No. 88-18

New Distributor Gear P/N 43-813776-1

Figure 1.

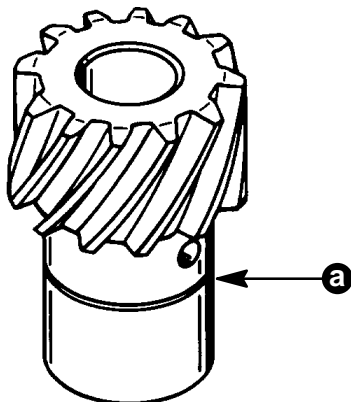
Distributor gear P/N 43-813776-1 supersedes gear P/N 43-47619-1. The new gear is nitrided and identified by a groove machined around the pilot end, below the roll pin of gear (Figure 1). The reason for the change is that our 4.3L engines with roller lifters have steel camshafts which can cause excessive wear on distributor gears without nitriding. This new gear has been in 4.3L production for several months. The old style gear has been purged from service stock and the new gear is in service stock and may be used in all applications. New 4.3L distributor assemblies P/N 90747A8 in service stock will come with the nitrided gear.

Figure 2.

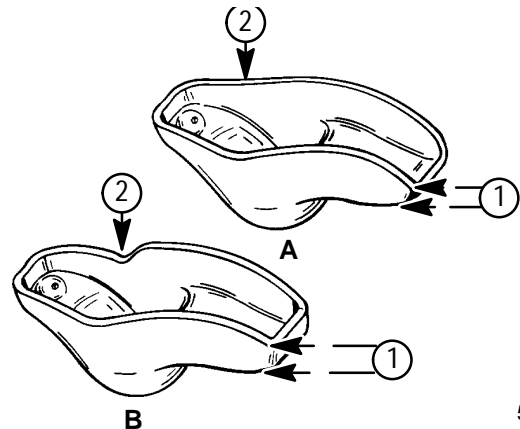
G.M. has informed MerCruiser that some of our 454 Magnum 365 HP could have rocker arms that are not heat treated correctly. The correct rocker are P/N 19241 is identified by the thickness of edge on rocker arm valve tip (Figure 2), not by a raised "L" on the valve end of the rocker arm as some preliminary information indicated (Figure 3). The correct rocker arms may or may not have any letter on the valve tip.

- A. Correct Rocker Arm
1. Approximate Thickness .220 – .240 (5.6 – 6mm)
 2. No dip in rail
- B. Incorrect Rocker Arm
1. Approximate Thickness .300 – .400 (7.6 – 10mm)
 2. Dip in this rail only
